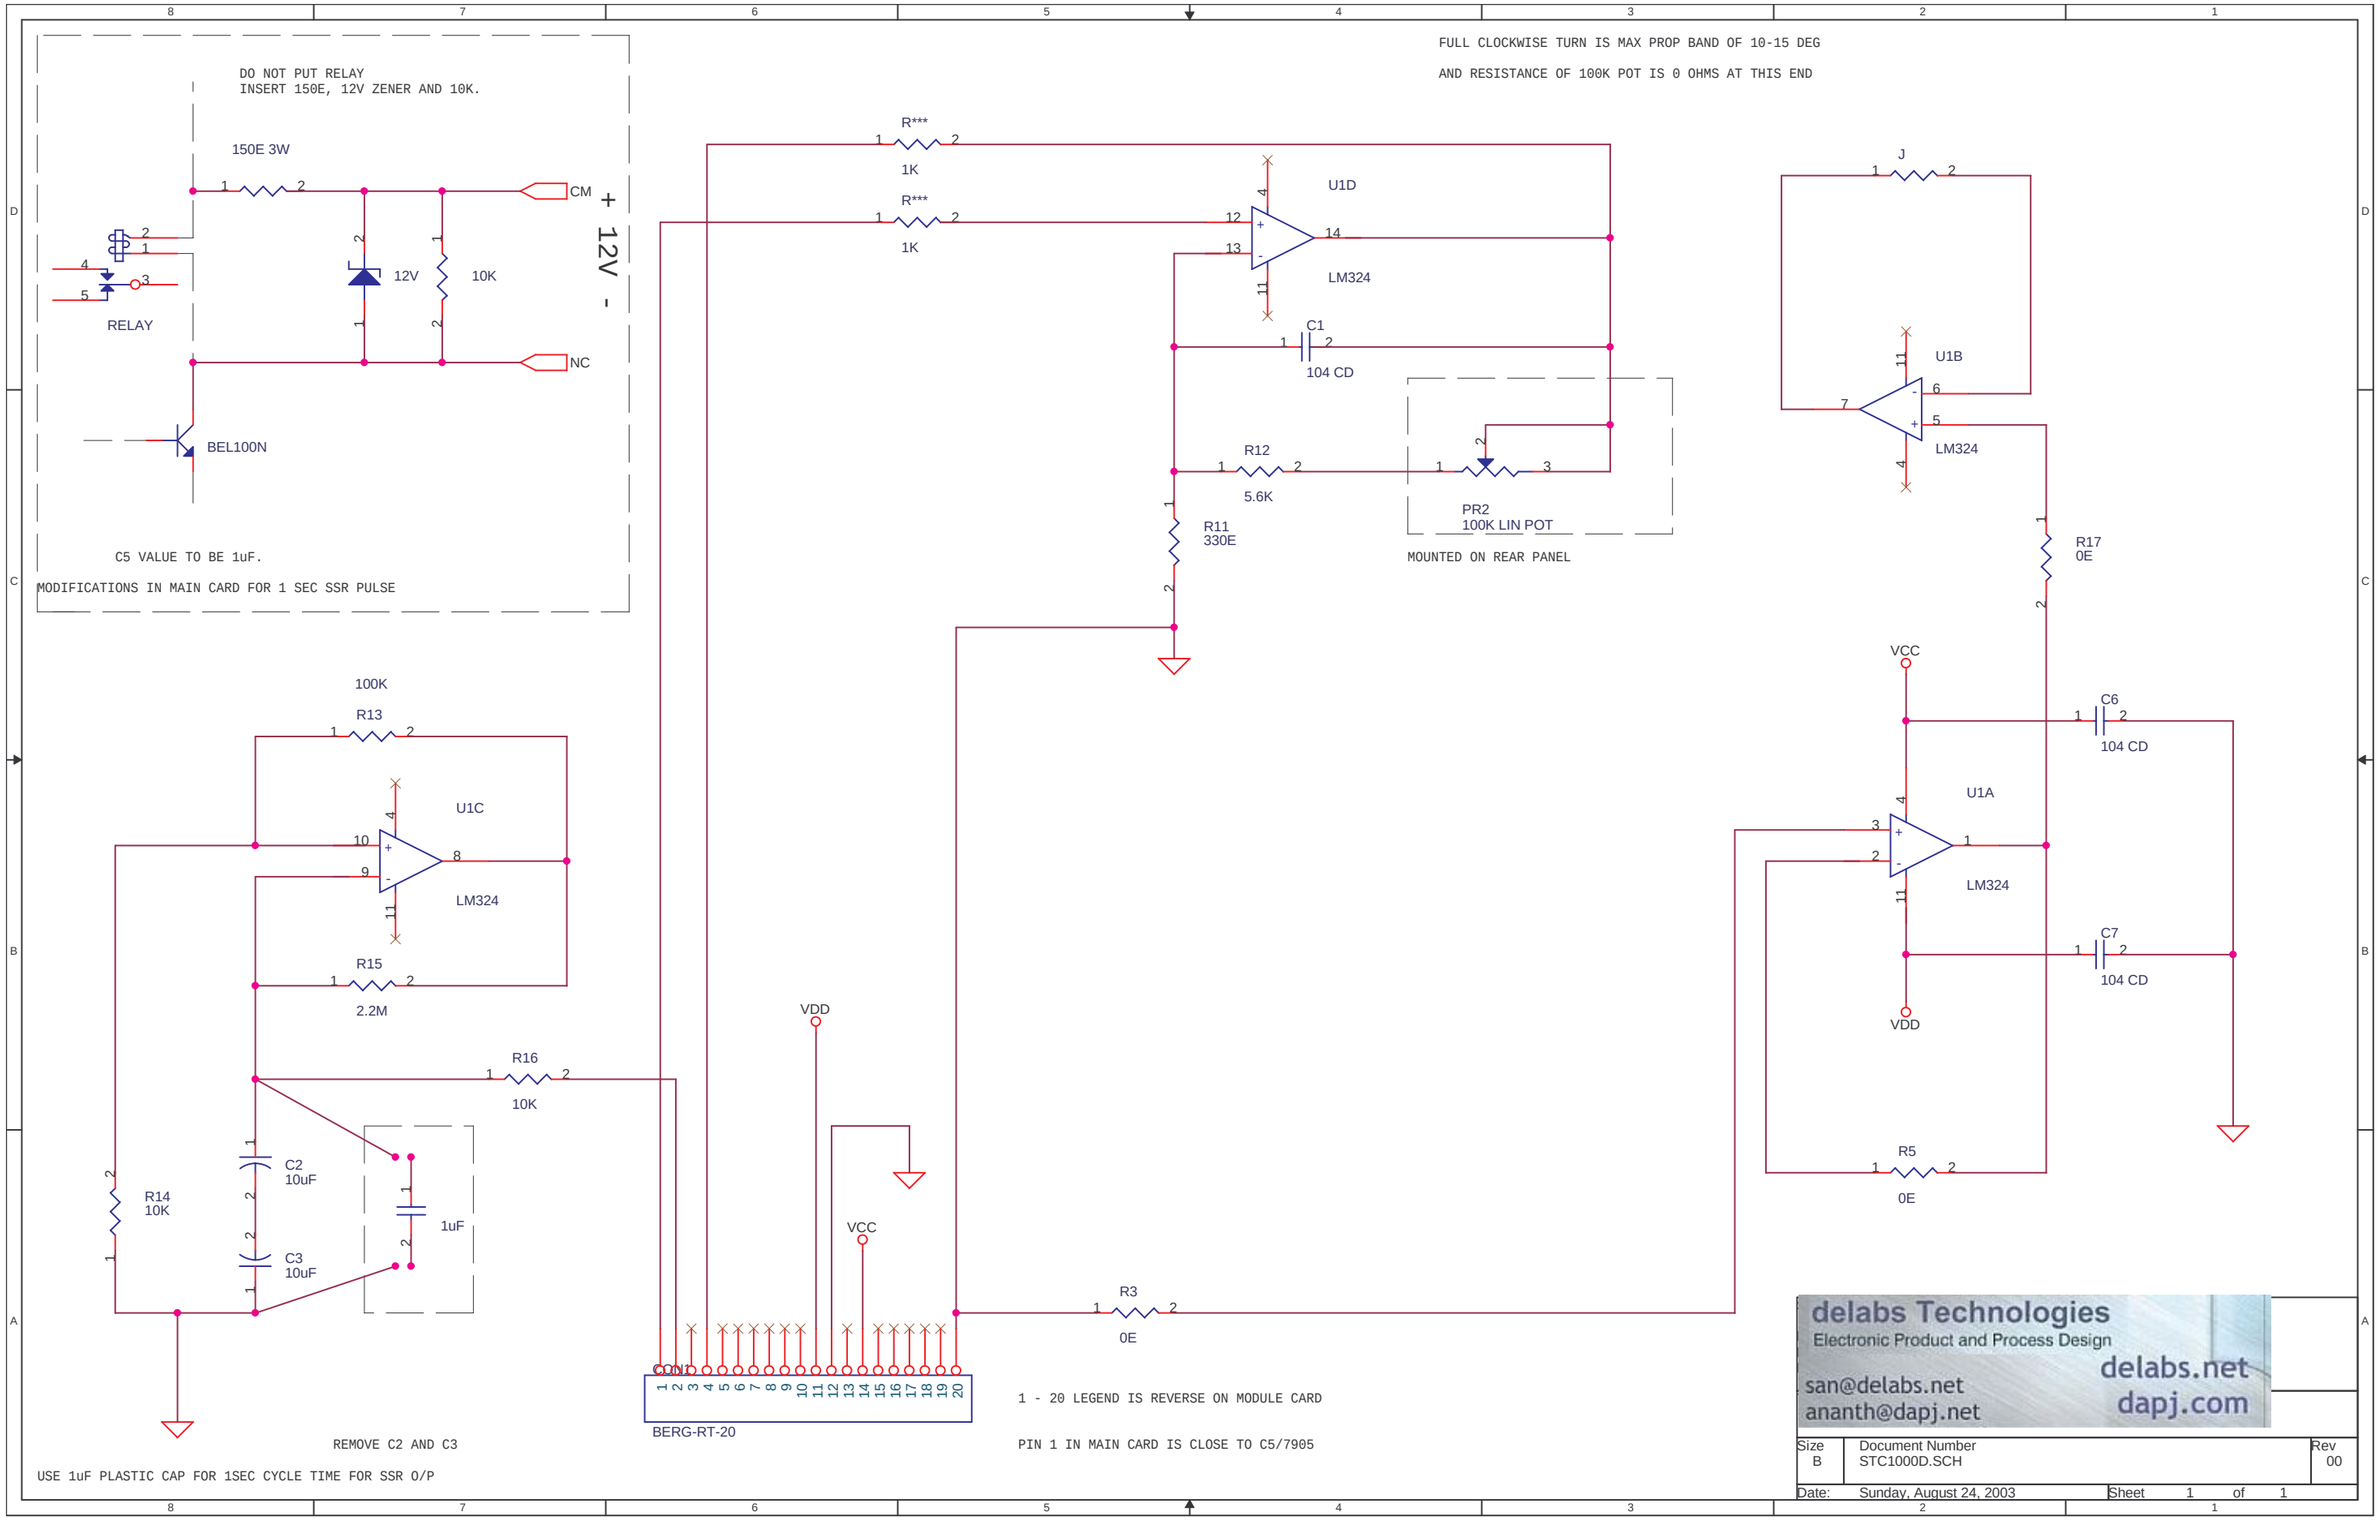
DO NOT PUT RELAY
INSERT 150E, 12V ZENER AND 10K.
150E 3W
CM
+ 12V -
12V
10K
RELAY
NC
BEL100N
C5 VALUE TO BE 1uF.
MODIFICATIONS IN MAIN CARD FOR 1 SEC SSR PULSE
FULL CLOCKWISE TURN IS MAX PROP BAND OF 10-15 DEG
AND RESISTANCE OF 100K POT IS 0 OHMS AT THIS END
R***
1K
R***
1K
U1D
LM324
C1
104 CD
R12
5.6K
R11
330E
PR2
100K LIN POT
MOUNTED ON REAR PANEL
J
U1B
LM324
R17
0E
VCC
C6
104 CD
U1A
LM324
C7
104 CD
VDD
R5
0E
100K
R13
U1C
LM324
R15
2.2M
R16
10K
R14
10K
C2
10uF
C3
10uF
1uF
VDD
VCC
R3
0E
COND
BERG-RT-20
1 - 20 LEGEND IS REVERSE ON MODULE CARD
PIN 1 IN MAIN CARD IS CLOSE TO C5/7905
REMOVE C2 AND C3
USE 1uF PLASTIC CAP FOR 1SEC CYCLE TIME FOR SSR O/P
delabs Technologies
Electronic Product and Process Design
delabs.net
dapj.com
san@delabs.net
ananth@dapj.net
Size B
Document Number STC1000D.SCH
Rev 00
Date: Sunday, August 24, 2003
Sheet 1 of 1
